AIR RESOURCES BOARD

Executive Order G-70-7-B

Relating to the Modification of the Certification of the Gulf/Hasselmann VCP-2 Service Station, Phase II Vapor Recovery System

NOZZLE CONFIGURATION

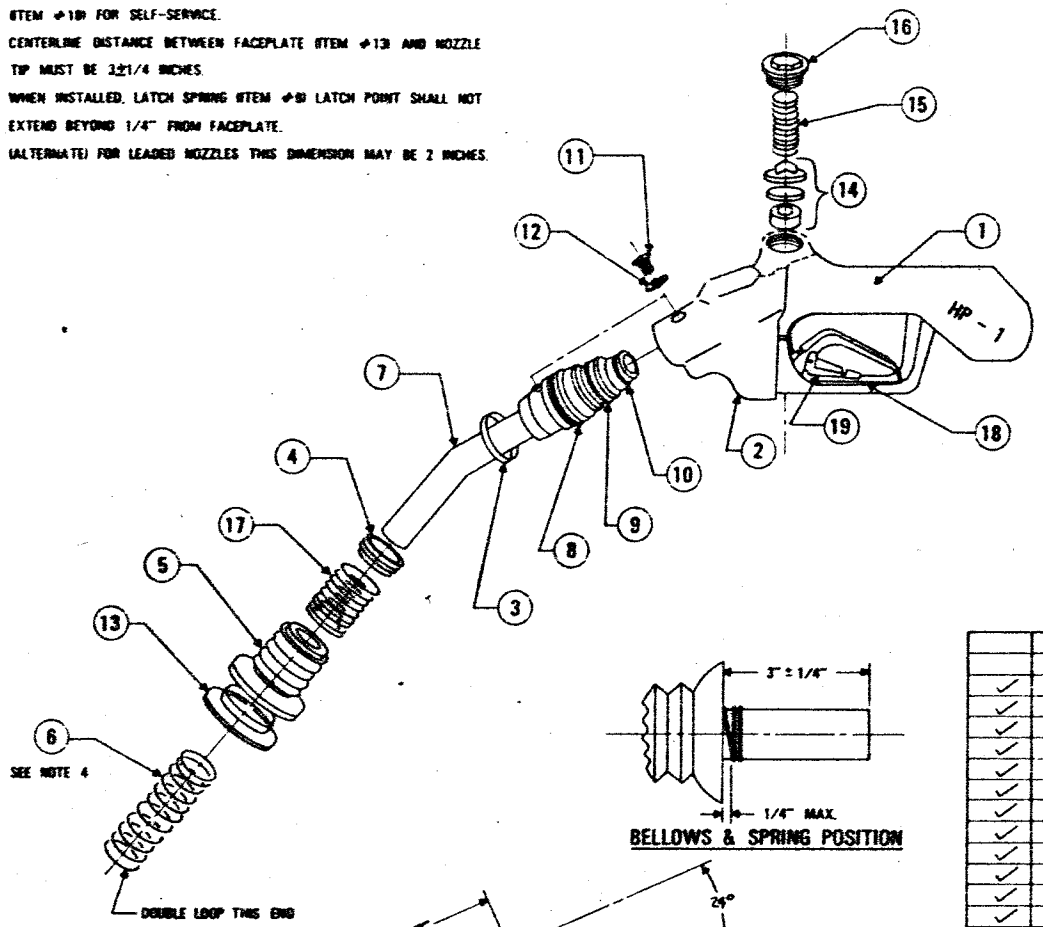
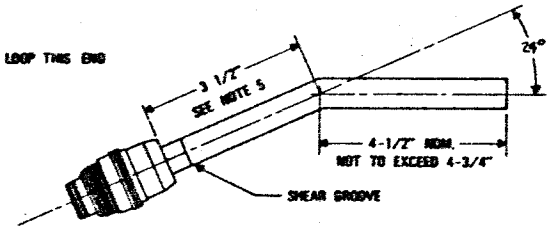
1. to require nozzle bellows and latch spring configurations as described in Exhibit 3;

1. NOZZLE TO MEET REQUIREMENTS OF UNDERWRITERS LABORATORY, INC., STANDARD 842 (1974).
2. REMOVE HOLD OPEN LATCH TRIGGER (ITEM #18) & TRIGGER SPRING (ITEM #19) FOR SELF-SERVICE.
3. CENTERLINE DISTANCE BETWEEN FACEPLATE (ITEM #13) AND NOZZLE TIP MUST BE 3±1/4 INCHES.
4. WHEN INSTALLED, LATCH SPRING (ITEM #9) LATCH POINT SHALL NOT EXTEND BEYOND 1/4" FROM FACEPLATE.
5. (ALTERNATE) FOR LEADED NOZZLES THIS DIMENSION MAY BE 2 INCHES.
